ADDENDUM to the Mount Ashland LSR Project SCENERY ANALYSIS

**Mount Ashland LSR Habitat Restoration & Fuels Reduction Project
(Mt Ashland Project)**

Date: **12/12/07 Addendum** to the original 4/6/07 Scenery Analysis

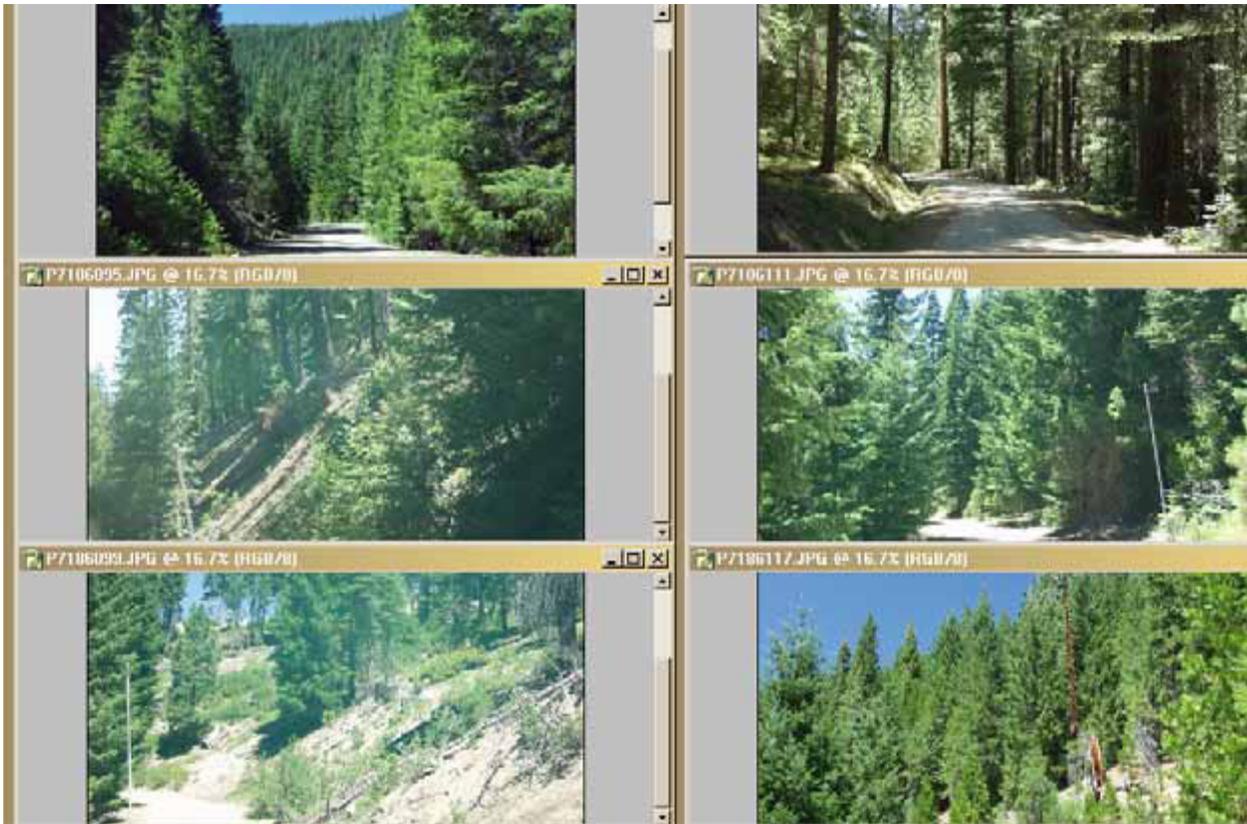
Below are photographic examples of immediate foreground road settings in which the above roadside design features would apply.

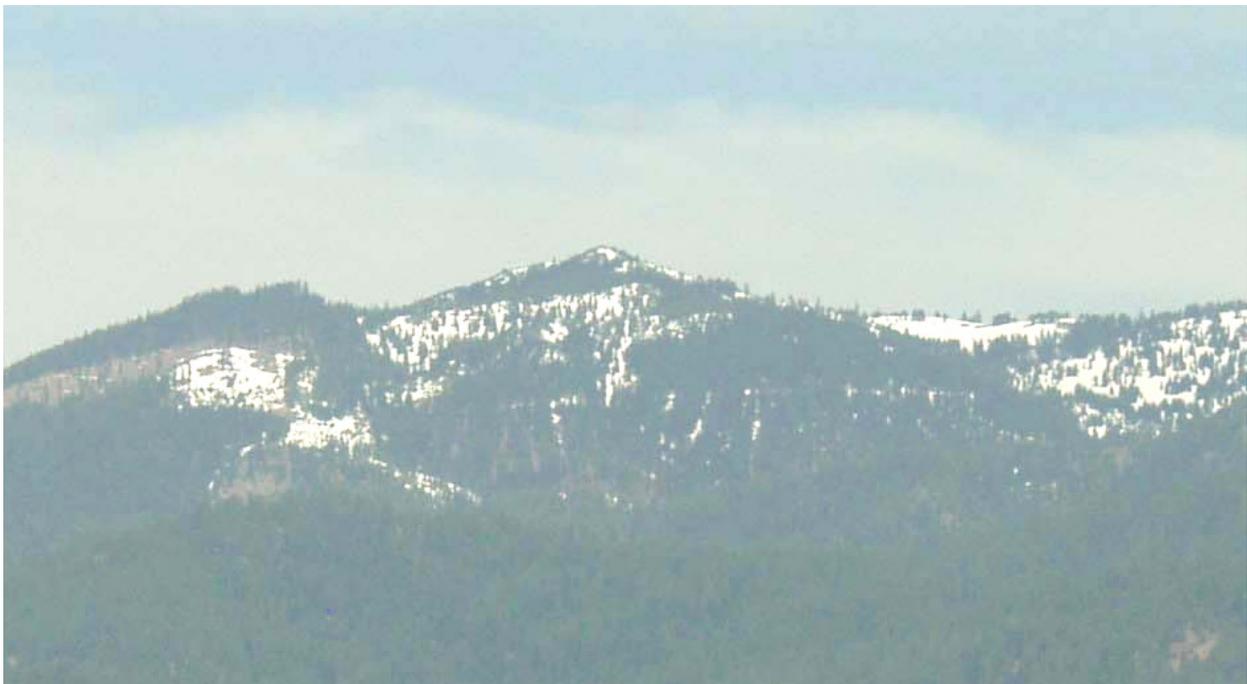
Vertical linear skyline yarding contrasts which are accentuated during the project area's 4-6 months of snow (below in center of photo), to be avoided by application of Scenery Design Standard #5 above.

5. To prevent unnatural appearing vertical linear openings in the forest canopy due to cable yarding corridors, retain at least 60% of the existing forest canopy cover within the yarding corridors of stands 236, 237, 250, 435, 243, 253, 206, 212, 207, 277 and 377. This may require an increased number of cable yarding corridors and/or the use of rub trees along the yarding corridors, or other methods, to reduce damage to retained trees and their screening branches.
